Independent Review of Hampstead Heath Ponds Project

AECOM has been appointed by the London Borough of Camden (the planning authority), to undertake an independent review of the proposed upgrading works to the ponds on Hampstead Heath, which are owned and operated by the City of London. The upgrading works are required to address the flood risk to downstream residents posed by the ponds. AECOM have been asked to review the proposed scheme, and comment on some key points contained in the objections. The Scope of the review is given by 5 questions from the Client, which summarise the key objection points

Figure 4.2: Flow through Highgate No 1 outflow pipe for 100 year, 1000 year, 10,000 year and PMF events

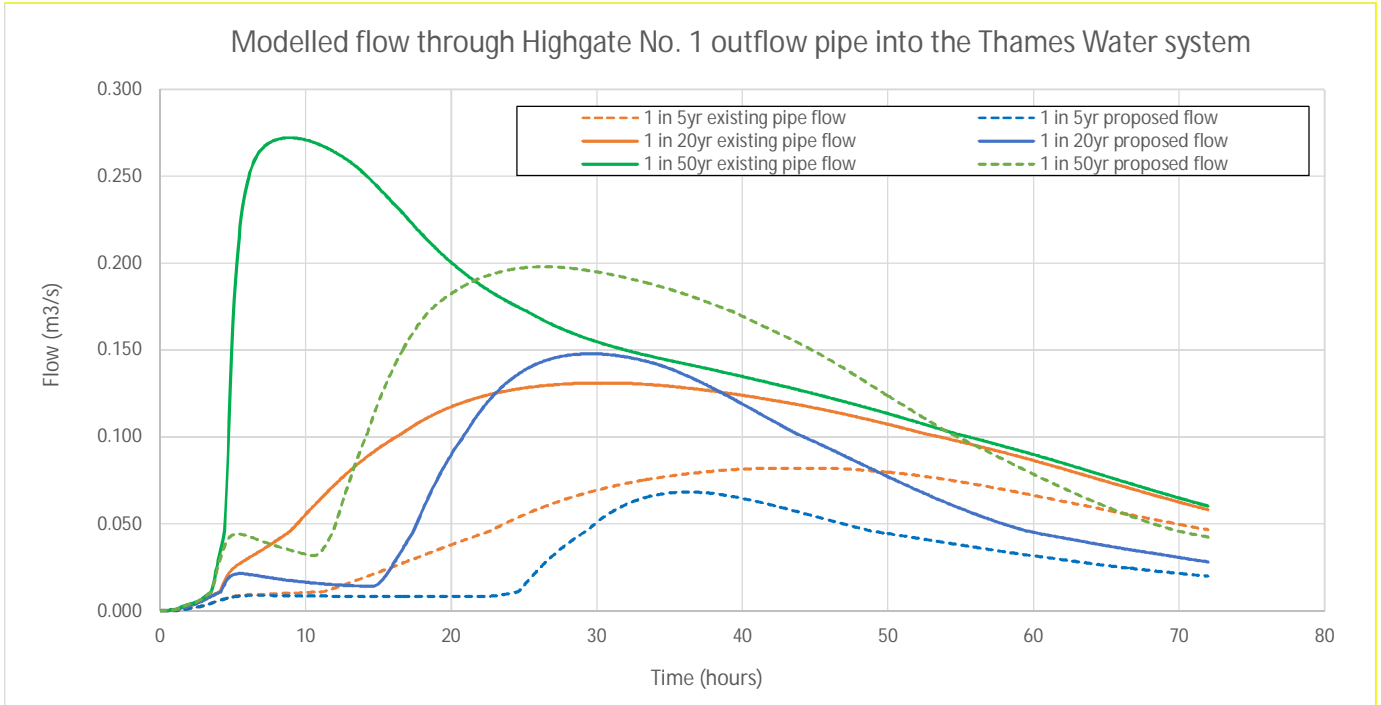
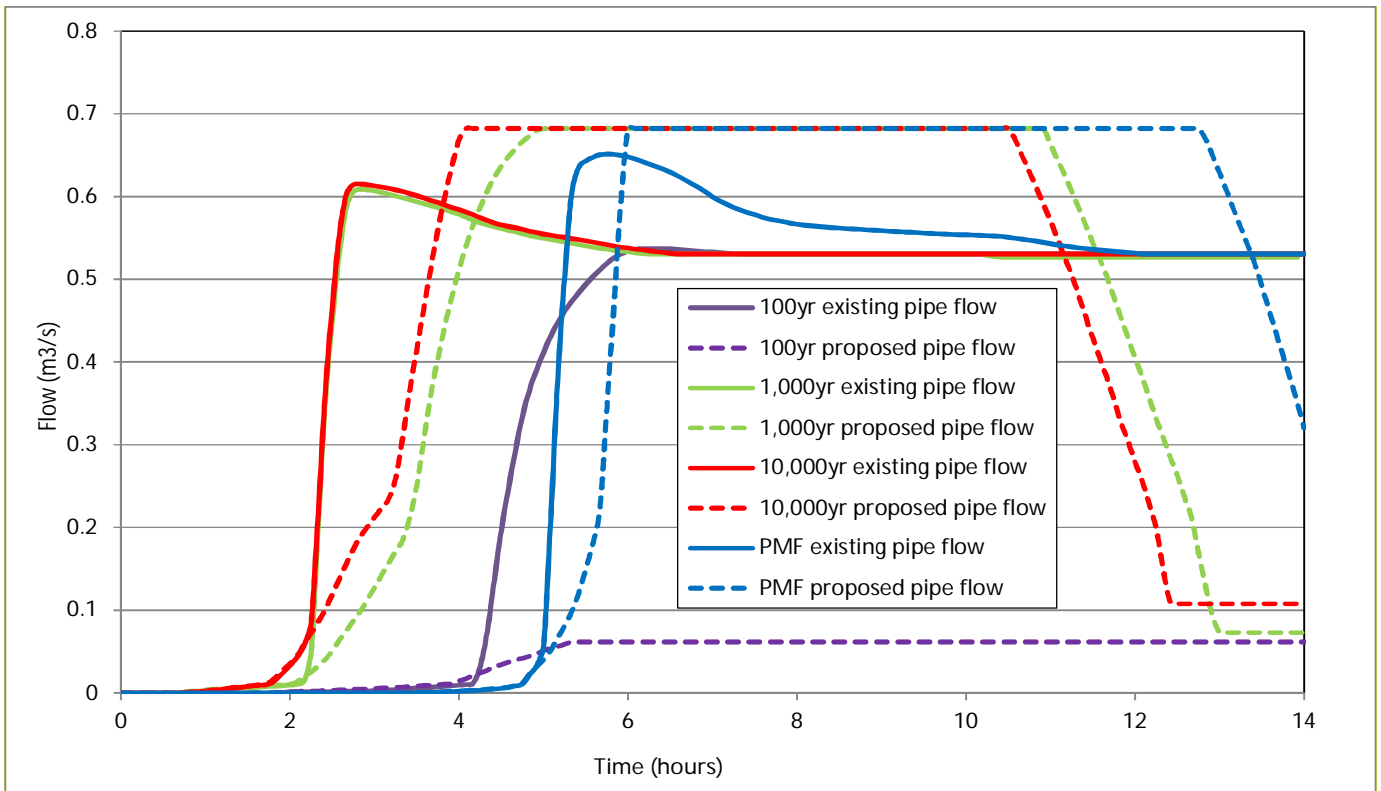
Atkins has provided us with the model results for both the lower return periods modelled for Thames Water, and for the 100 year, 1,000 year, 10,000 year and PMF, shown in the figures below for Highgate No 1. Note the 100 year proposed pipe flow result appears anomalous. We would have expected that the lower return period events would have been for the critical storm duration quoted in the Assessment of Design Flood report (2.9 – 3.9 hours). However it is clear that the results are from a much longer storm duration, and will therefore not show the highest peak flows. Nevertheless, neither of these apparent anomalies has any significant consequence on the scheme design or effects downstream of the proposed scheme and we are still able to draw the following conclusions:

These show that the discharge from Highgate No 1 reduces significantly in terms of both flow and volume for the lower return periods. The discharge from Hampstead No 1 outlet pipe reduces in terms of peak flow, and a very slight increase in volume (2-4%) which is not significant.

Because the results are for different storm durations, there is a discontinuity between the volumes discharged into the drainage network at lower return periods (5 year, 20 year and 50 year) and the higher return periods (Table 4.1 for Highgate). Nevertheless, there is a consistent reduction in volume over 72 hours for the lower return period events, and over 14 hours for the higher return period events between the existing and proposed pipe flow.

4.3 Modelling of Highgate No 1 outlet pipe

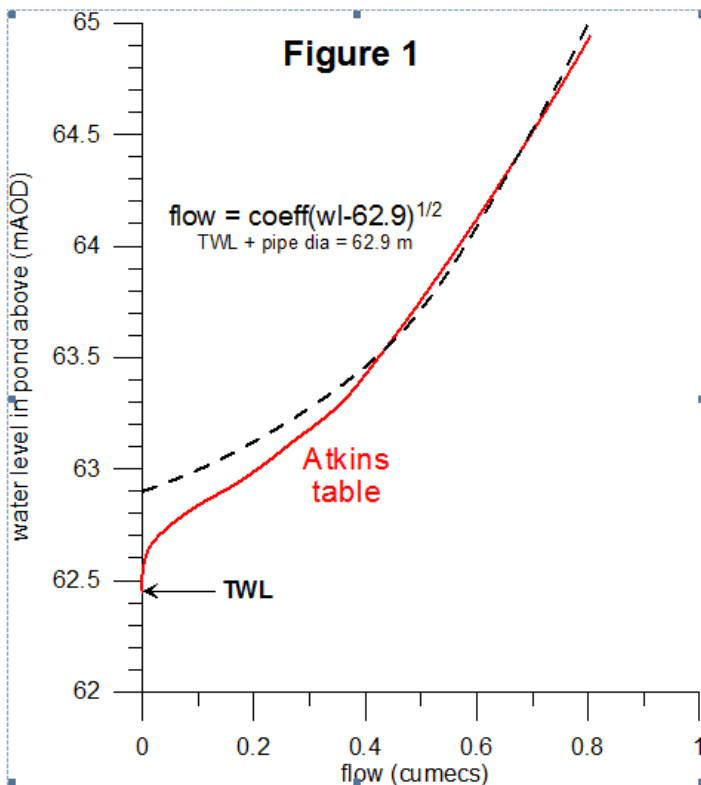
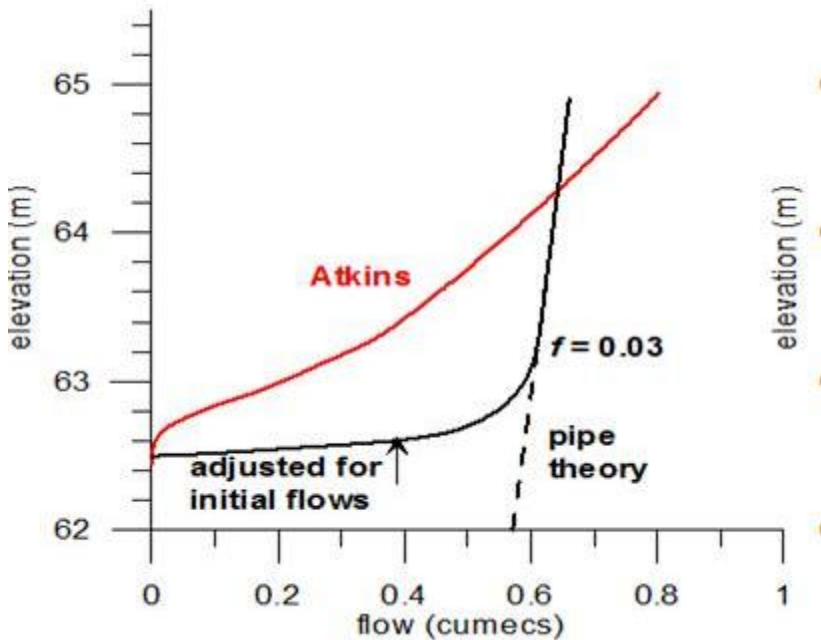
We have been asked to include in our review, comments received from Brookfield Mansions Ltd, which include a paper from Professor K R Rushton regarding the overflow from Highgate No 1. In it, he presents a graph showing the Atkins rating curve for the Highgate outlet pipe (in red below), and from it, draws the conclusion that Atkins have used some form of orifice equation to calculate the flow through the Highgate No 1 outlet pipe.

Professor Rushton goes on to explain that the flow through the pipe should not be estimated by orifice theory, but by hydraulic pipe theory. He has plotted the difference in the graph below.

In fact, the hydraulics of the overflow pipe will be a combination of types of hydraulic flow. To start with, when the inlet of the pipe is not submerged, the flow will be controlled by a weir type flow at the inlet. As the water level rises and begins to submerge the inlet, orifice flow will occur. As the downstream pipe is supercritical, this flow type will continue until the pipe approaches full, at which point air will be expelled and full pipe flow will govern the discharge. The discharge curve will therefore follow Atkin’s red line until it is intersected by the black line, whereupon it will follow the pipe theory curve. For Highgate No 1, this transition point between orifice theory and pipe theory occurs when the reservoir level is above the crest of the dam and therefore the stage is not reached where this would come into effect. Atkins discharge curve is consistent with this and we consider their rating curve to be appropriately derived within the normal limit of accuracy of standard hydraulic calculations.

Figure 4.3: Existing and proposed flow discharged overland downstream

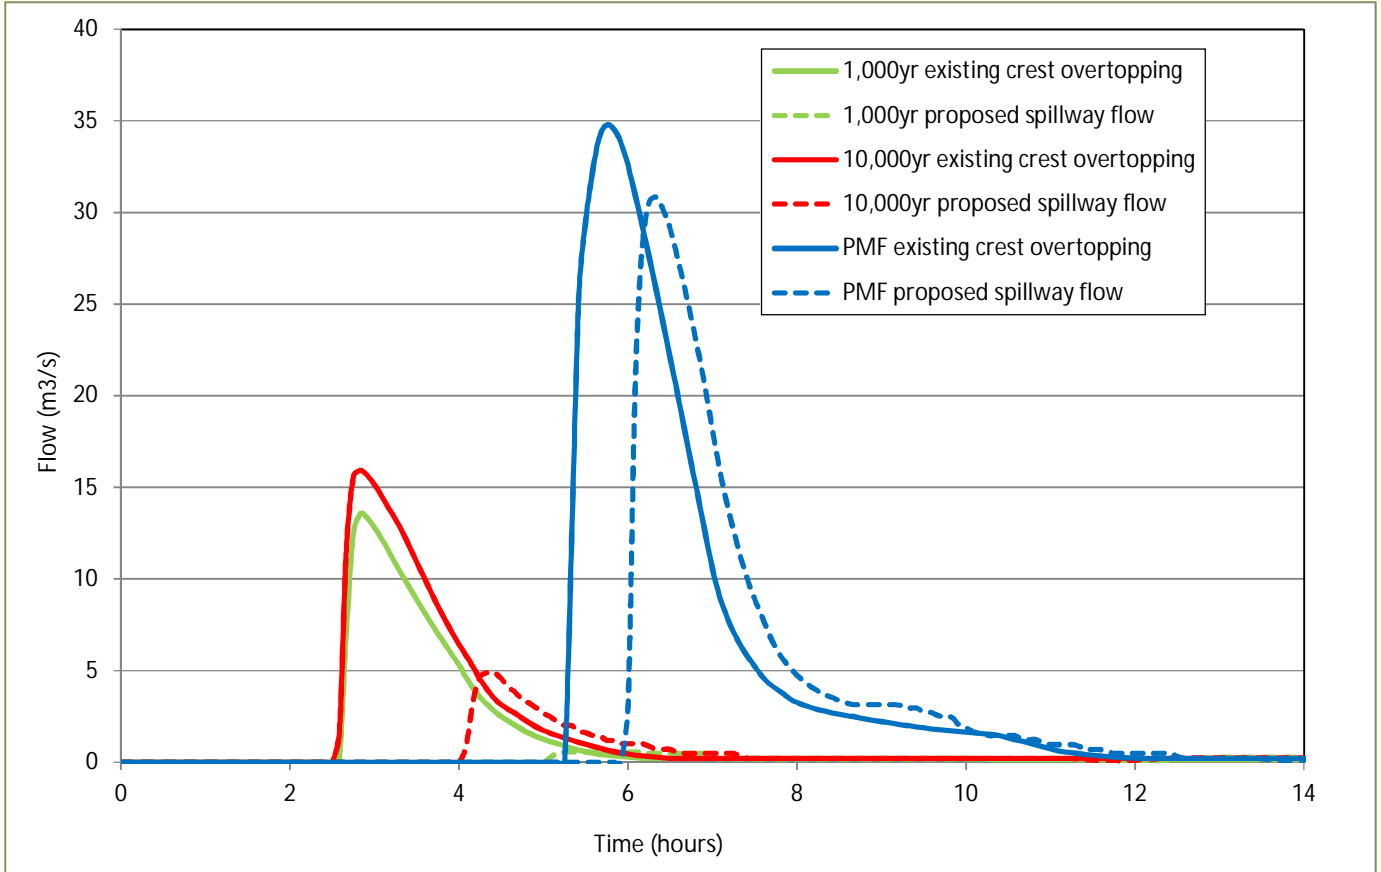
Flood event	100yr	1,000yr	10,000yr	PMF
Existing crest overtopping	17,772	65,362	81,981	199,285
Proposed spillway flow	0	0	26,847	157,508

Figure 5.1: Risk framework

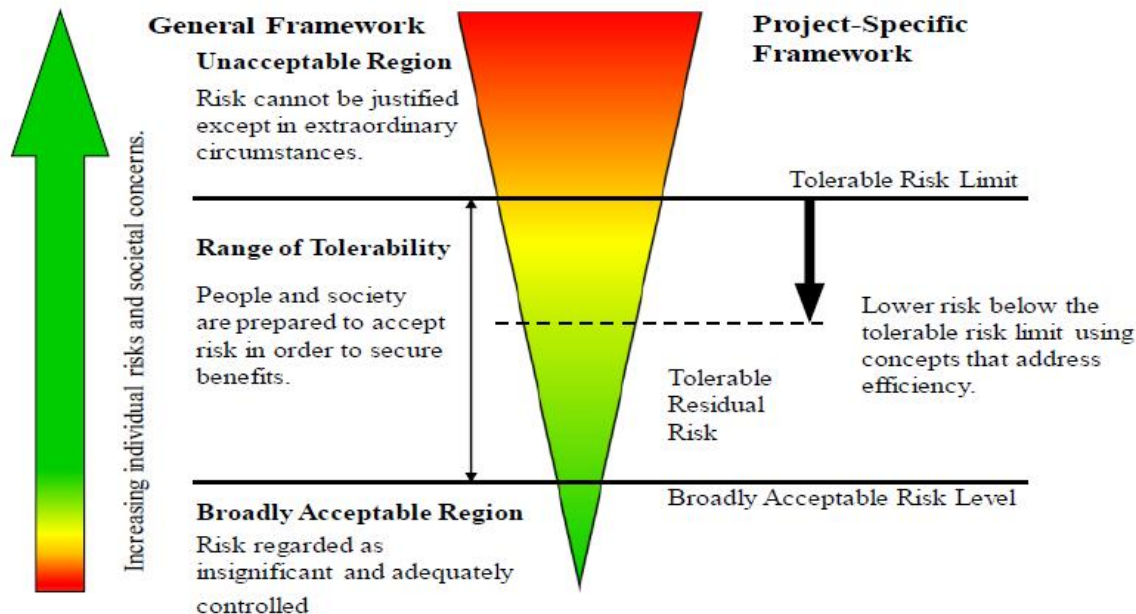
16 and 17. Please calculate ASLL based on the recommended minimum of 2 hours warning....Figure 5.1: this shows a line showing the reduction in LLOL with 60 mins warning. Please show the line for 2 hours warning

It is not appropriate to assume any warning time as explained above. Figure 5.1 is from standard guidance and does not include a line for 2 hours warning.

Figure 5.3: Risk evaluation

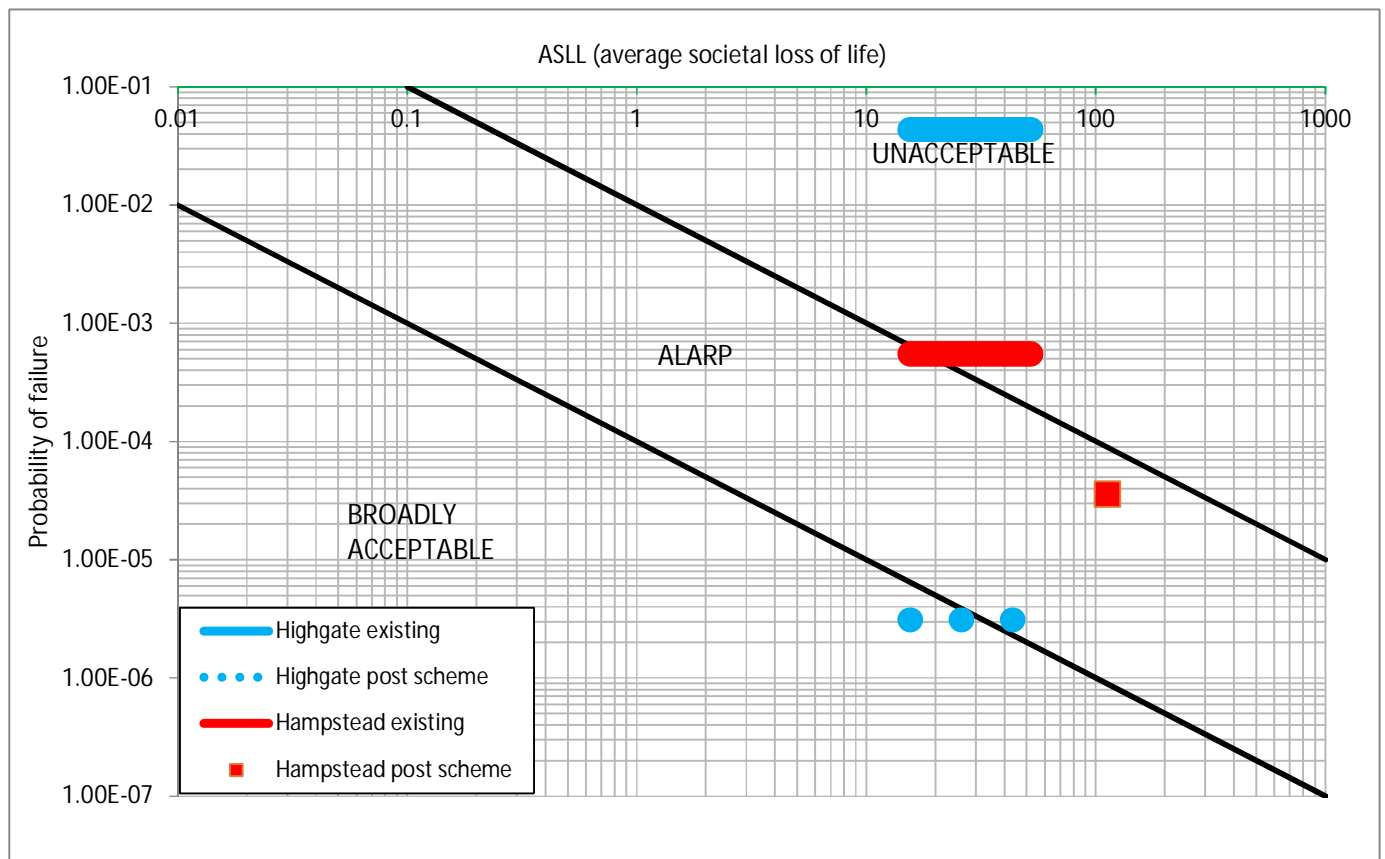
This indicates that the proposed scheme successfully reduces the risk to society for both the Highgate chain and Hampstead chain to a tolerable level, although it indicates the importance of including additional work where practicable to reduce the risk of internal erosion on the Hampstead chain. It certainly does not indicate that the reduction in risk is excessive nor gives justification that the works could be designed for a lower return flood period event.

The proposed scheme reduces the risk to the dams from flood to a level where the greatest residual risk lies with other causes of failure. It is understood that where other potential defects and deficiencies at the dams are identified as significant, such as blocked outlet pipes and an area of settlement and leakage at Mens Bathing Pond Dam, measures will be included in conjunction with the works to reduce these risks where reasonably practicable.

*ASLL for Hampstead post scheme is greater because the applicable ASLL figure is the total, not the incremental value
